R.E. Ginna Nuclear Power Plant

**Subject:** License Amendment Request Regarding Main Feedwater Isolation Valves  
R.E. Ginna Nuclear Power Plant  
Docket No. 50-244

**Subject:**       Revision to Technical Specification 3.7.3 to Incorporate Replacement of Main Feedwater Pump Discharge Isolation Valves with Main Feedwater Isolation Valves

### **Insert B 3.7.3-5A**

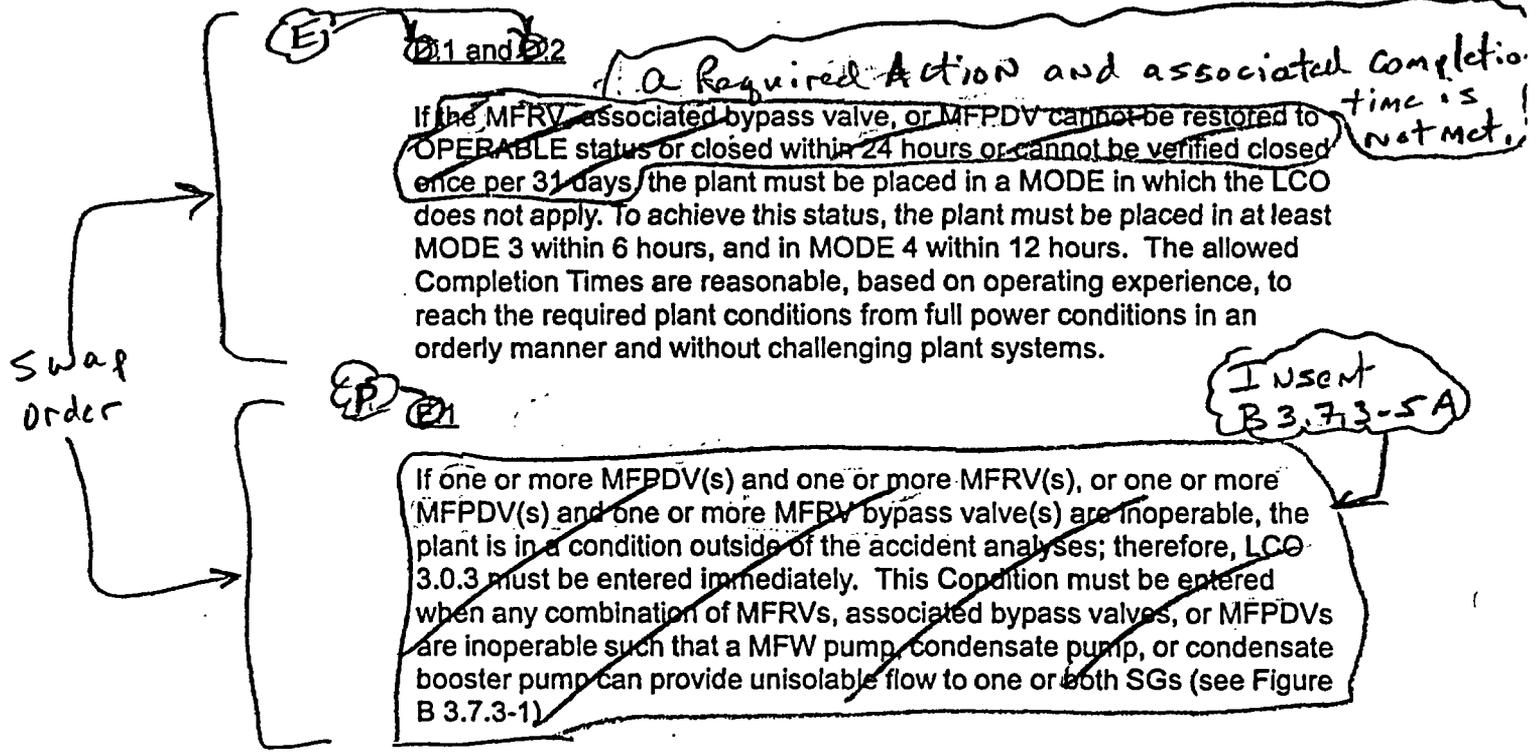
With two inoperable valves in the same flow path, there may be no redundant system to operate automatically and perform the required safety function. Although the containment can be isolated with the failure of two valves in parallel in the same flow path, the double failure can be an indication of a common mode failure in the valves of this flow path, and as such, is treated the same as a loss of the isolation capability of this flow path. Under these conditions, affected valves in each flow path must be restored to OPERABLE status, or the affected flow path isolated within 8 hours. This action returns the system to the condition where at least one valve in each flow path is performing the required safety function. The 8 hour Completion Time is reasonable, based on operating experience, to complete the actions required to close the MFIV or MFRV, or otherwise isolate the affected flow path.

Figure B.3.7.3-1  
 MFRVs Associated Bypass Valves  
 and MFPDVs

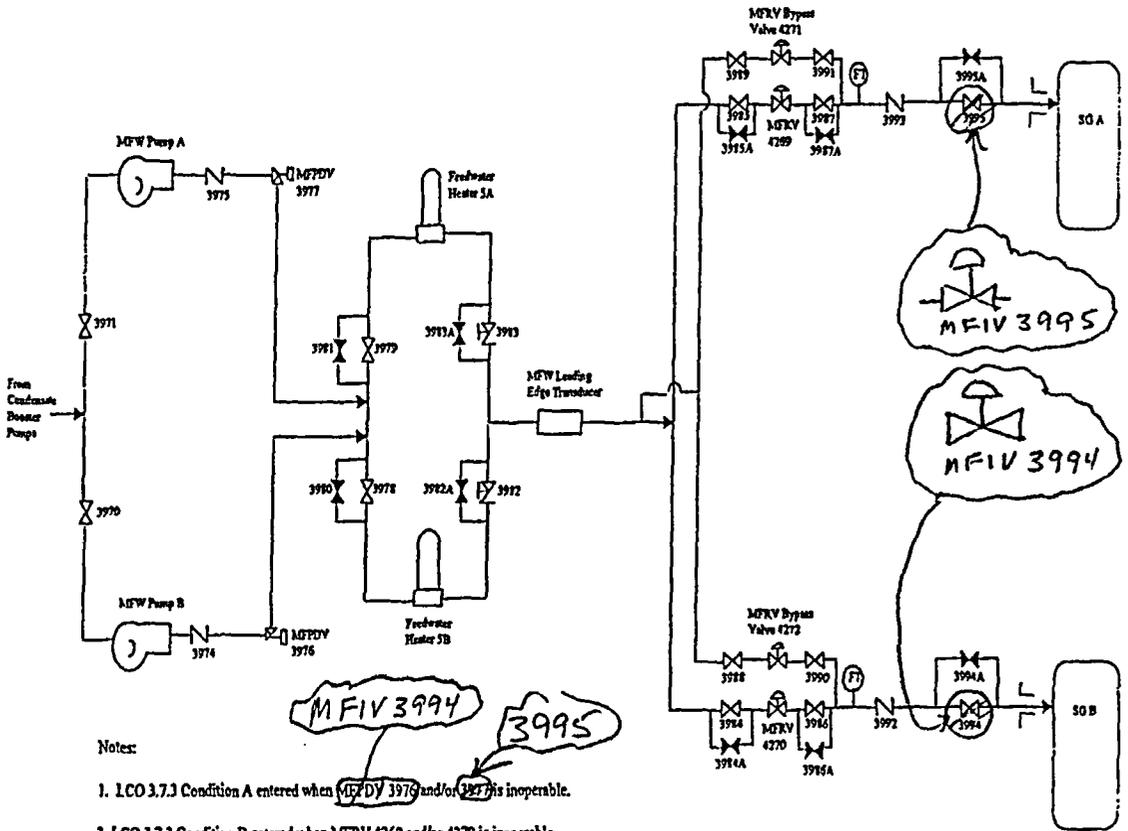
The MFRVs, associated bypass valves, and MFDPVs in conjunction with check valves located downstream of the isolation valves also provide a pressure boundary for the controlled addition of auxiliary feedwater (AFW) to the intact SG (see Figure B 3.7.3-1).

Figure 1

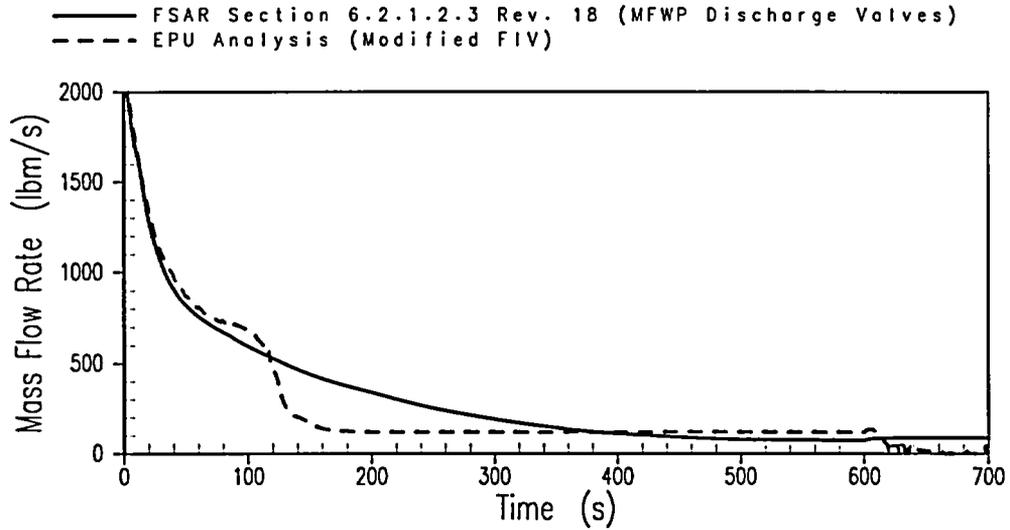
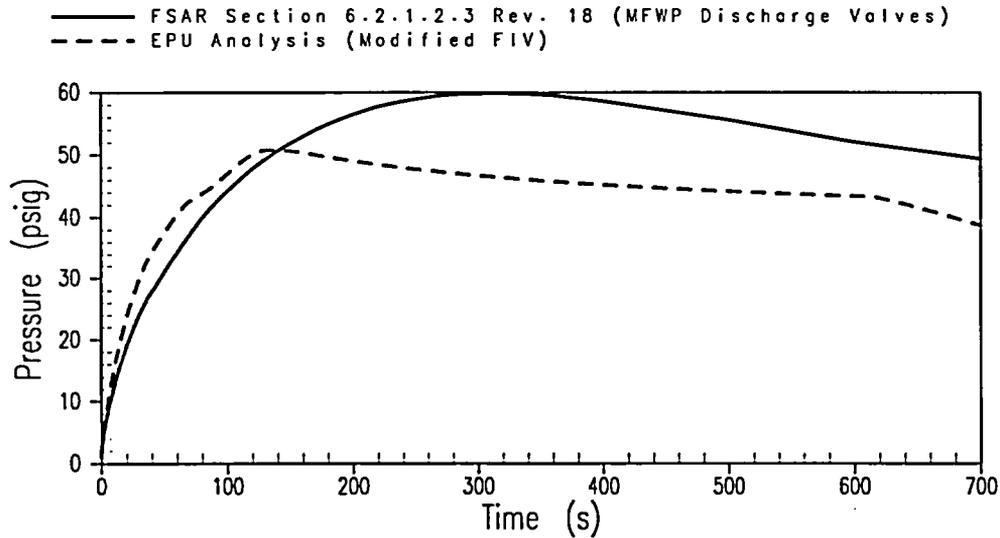
Figure 1 and Figure 2 compare this limiting case from the FSAR to the new analysis which has credited feedwater isolation due to the automatically actuated MFIV with a stroke time of 30 seconds. In the first 120 seconds, there is a higher release rate and a higher containment pressure due to the EPU effects and a lower shutdown margin (1.3%). However, the MFIV closure limits the main feedwater addition to less than 20,000 lbm, which substantially improves the longer-term containment pressure transient. The peak containment pressure is reduced from 59.8 psig to 50.8 psig.

Figure 3

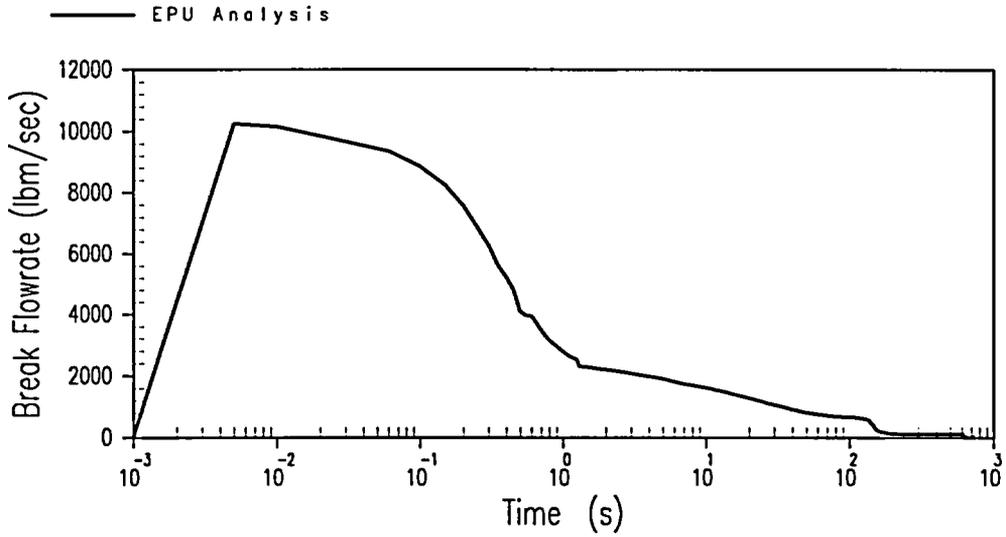
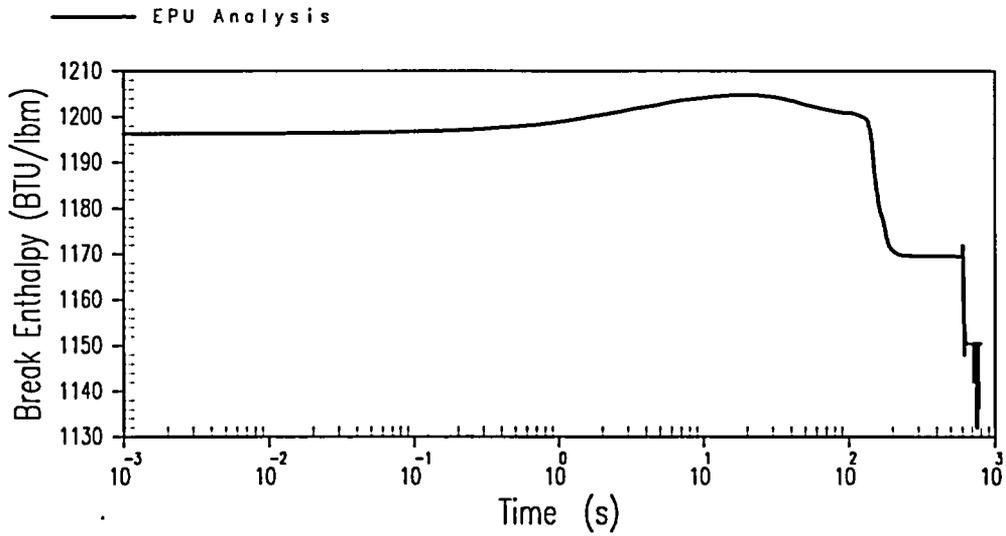
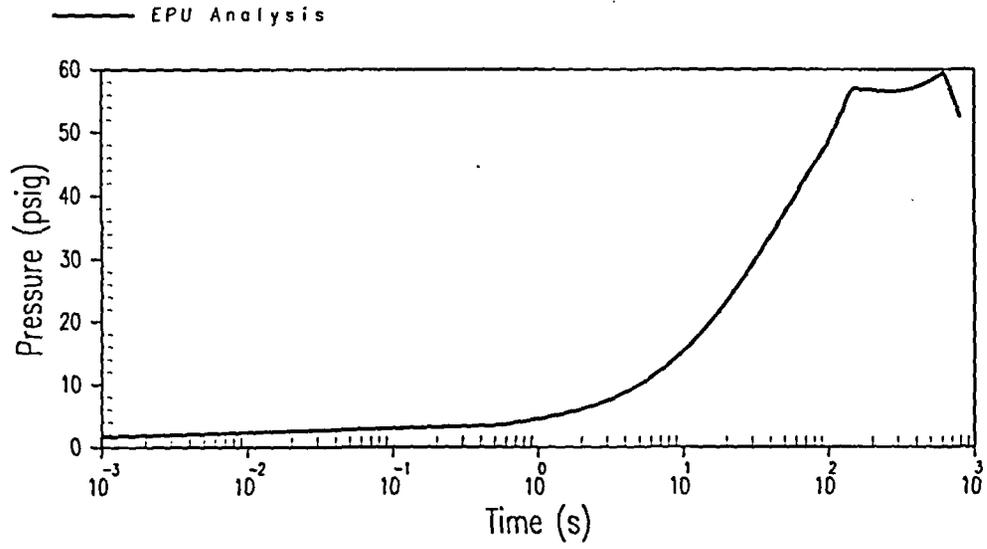
With the modified MFIV, an MFRV failure is no longer the limiting single failure for the steamline break containment response analysis. The limiting case definition changes to a vital bus failure with an initial power level of 70%. The sequence of events for this limiting case is listed in Table 4. The break flowrate is shown in Figure 3, the break enthalpy is in Figure 4, and the containment pressure transient is in Figure 5. The peak containment pressure is 59.4 psig, which is below the containment design pressure of 60.0 psig.

**Figure 1**  
**Ginna Station**  
**Steamline Break at Hot Zero Power – 1.4 ft<sup>2</sup> Break**  
**(with Offsite Power Available, Unisolatable Steam Paths)**  
**Nuclear Power, and Core Heat Flux vs. Time**

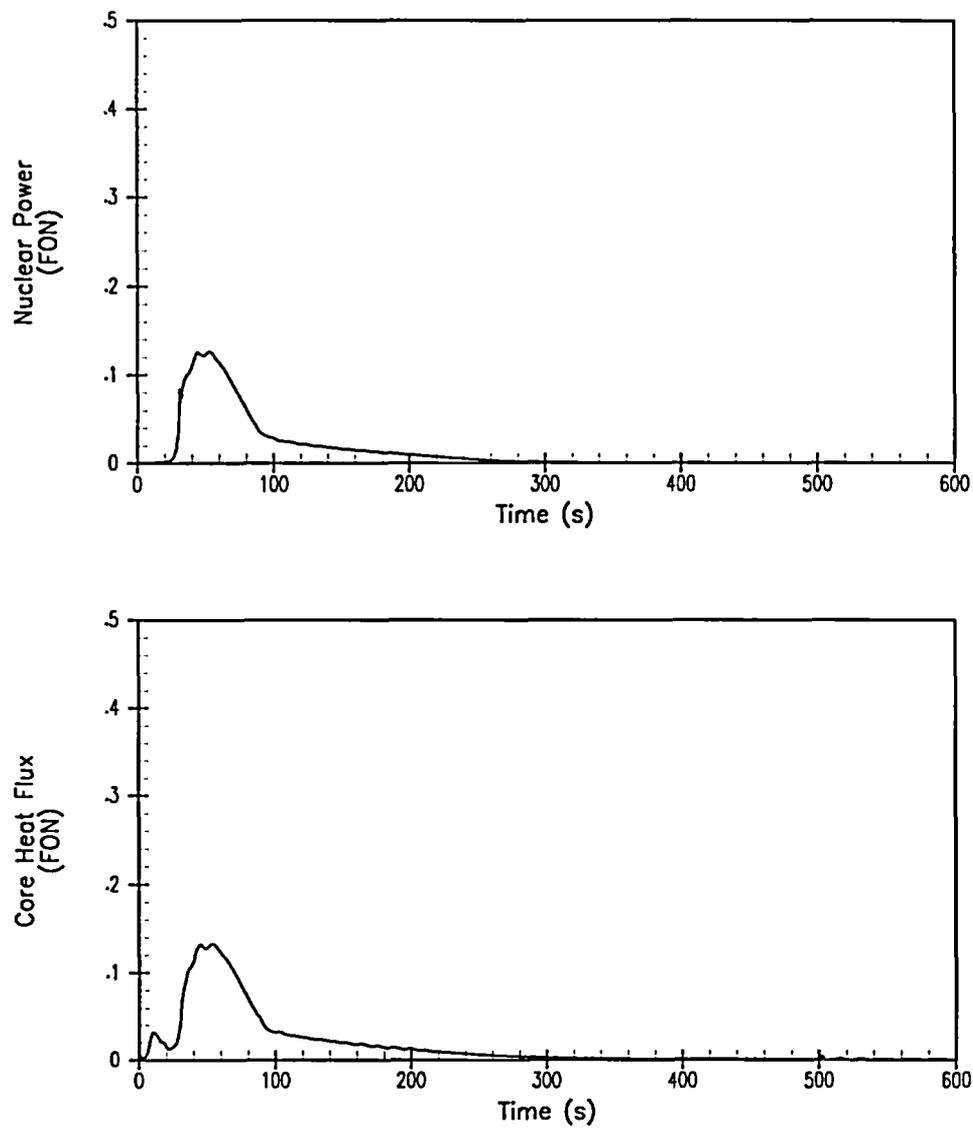
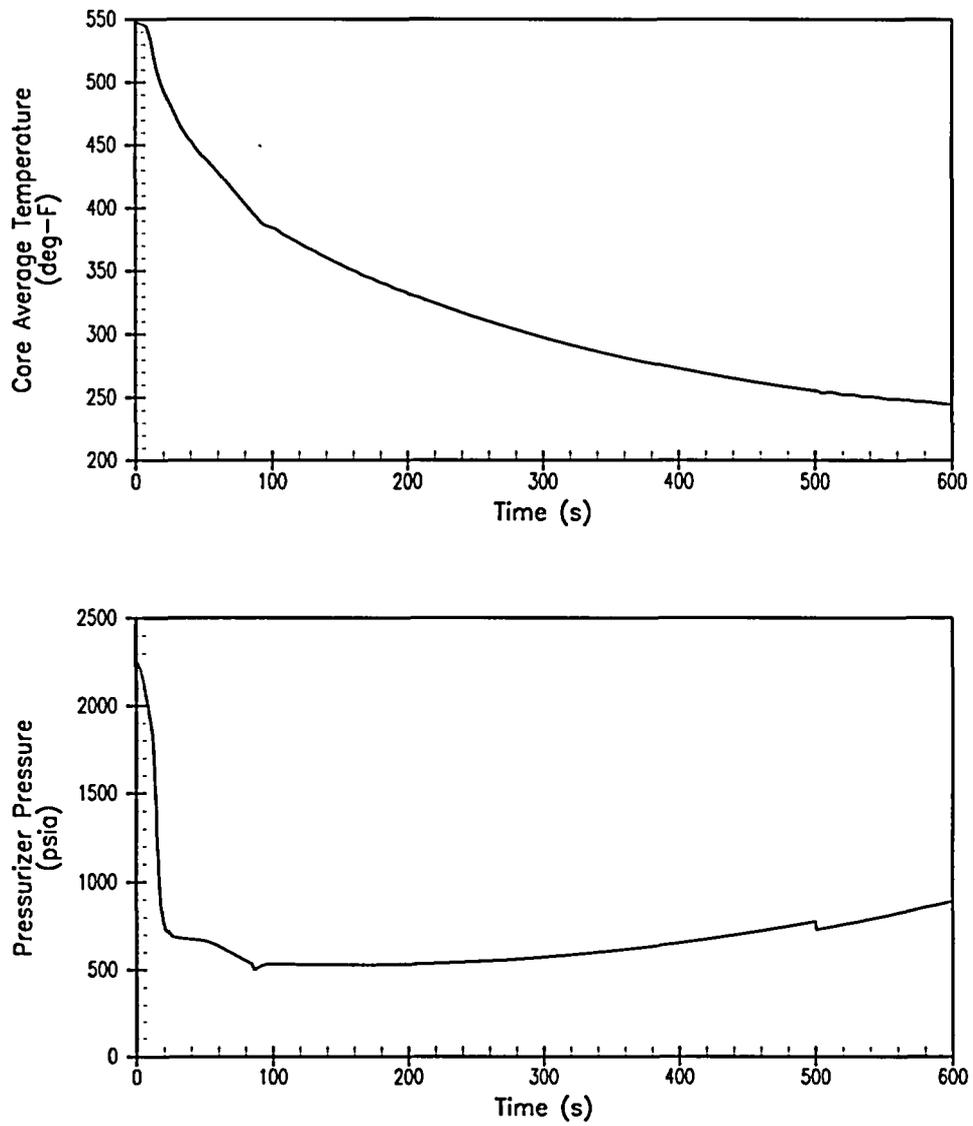
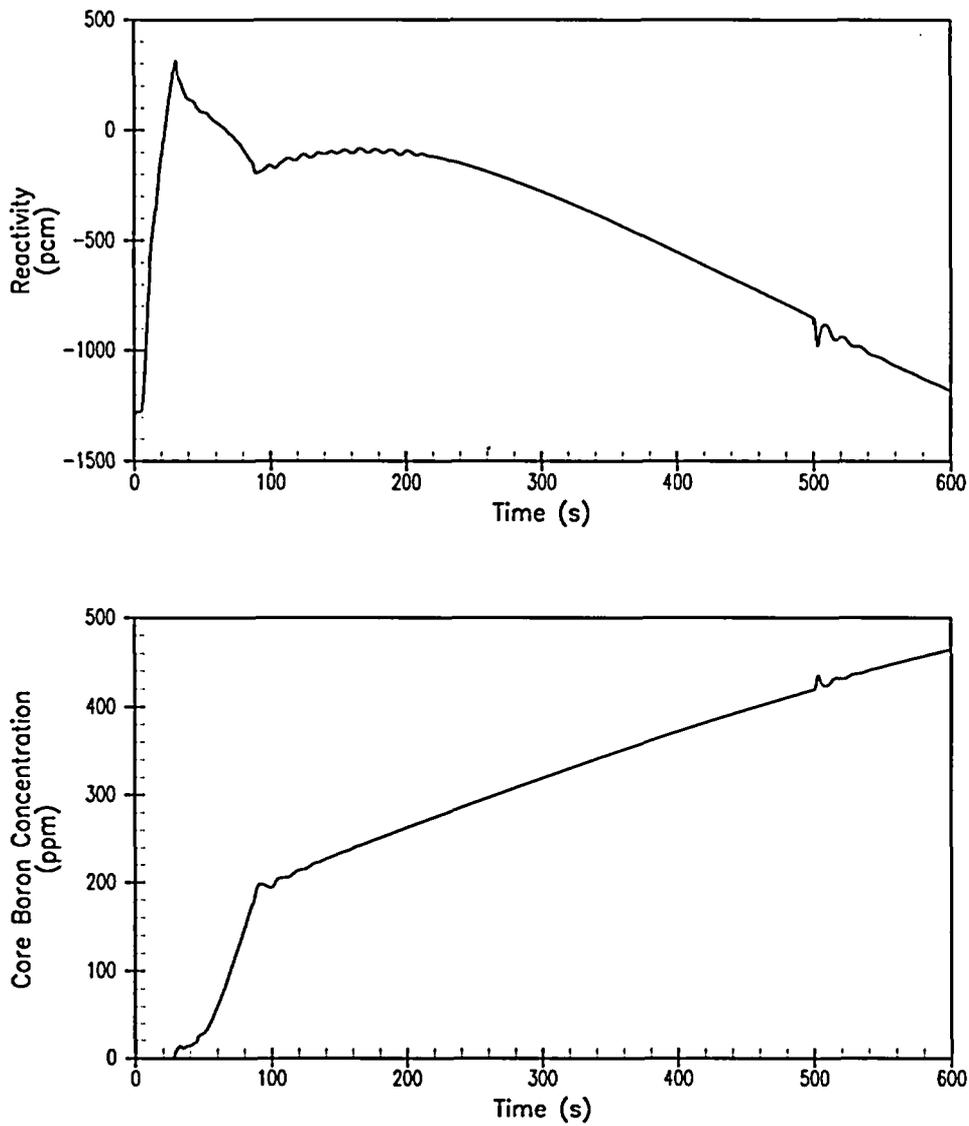
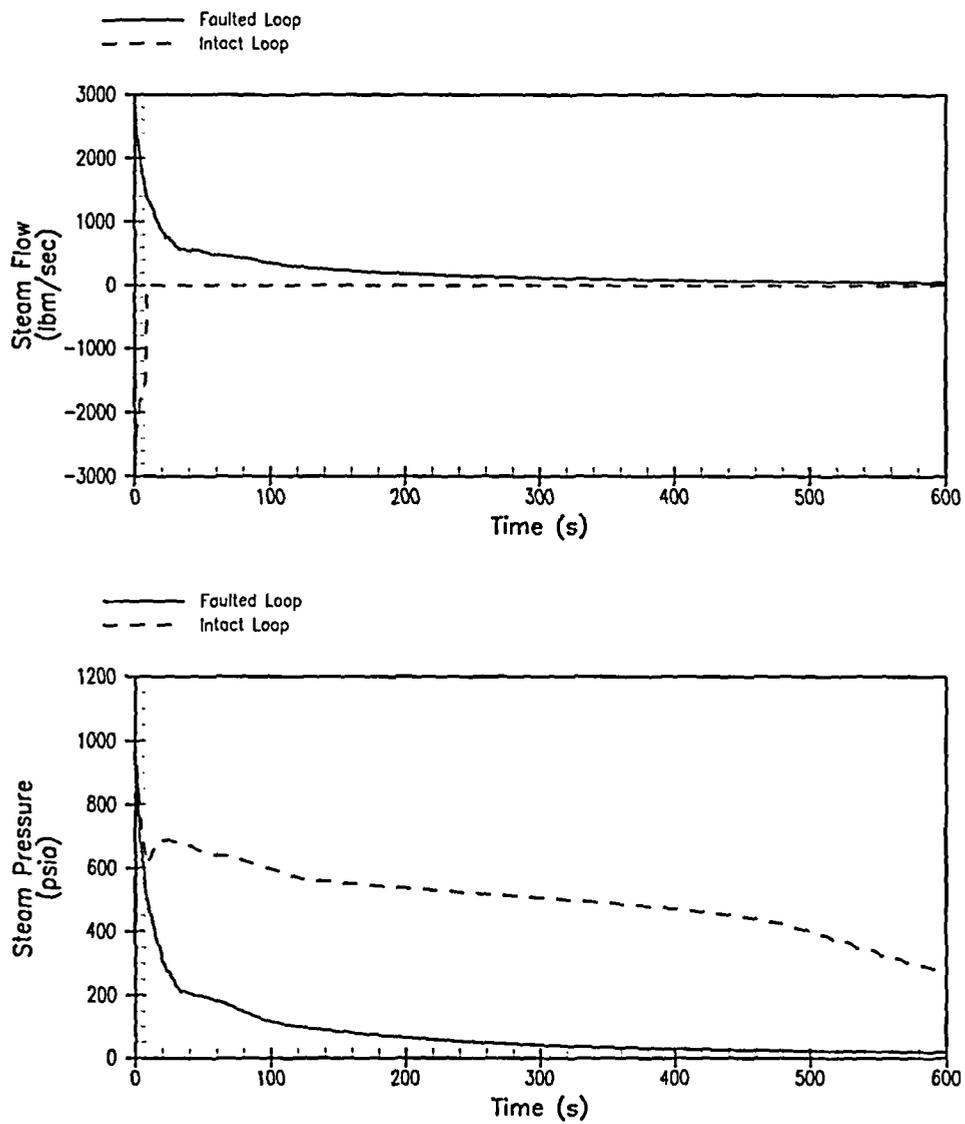
The calculated sequence of events for the most limiting case is shown in Table 1. Figures 1 through 4 show the transient results for the most limiting case for Ginna. These figures show transient results following a 1.4 ft<sup>2</sup> main steamline rupture at initial no-load conditions with offsite power available. Since offsite power is assumed available, there is full reactor coolant flow.

As shown in Figure 3 the core attains criticality with the RCCAs inserted (i.e., with the plant shutdown assuming one stuck RCCA) before boron solution from the ECCS enters the RCS.
